Service Bulletin

Bulletin No.: 23-NA-006

Subject: Instrument Panel Trim Plate Applique Loose

Brand:	Model:	Model Year:		VIN:		Engine:	Transmission:
		from	to	from	to		
Chevrolet	Suburban	2021	2023				
	Tahoe						
GMC	Yukon Models

6258556

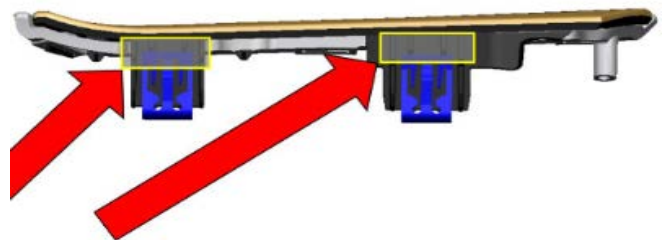
Involved Region or Country	North America
Condition	Some customers may comment on the instrument panel trim plate applique is either loose and/or has fallen off.
Cause	The cause of the condition may be due to the retention clip coming unsecured.
Correction	Apply foam tape to the tower holding the retention clips and reinstall.

If you encounter a vehicle with the above concern, remove the instrument panel trim plate applique and apply Kent foam tape (or equivalent) to the bottom of the part on the side ribs of the tower holding the clip like illustrated above. Refer to *Instrument Panel Trim Plate Applique Replacement - Left or Right Side*. Once the reinstalled, verify condition is corrected.
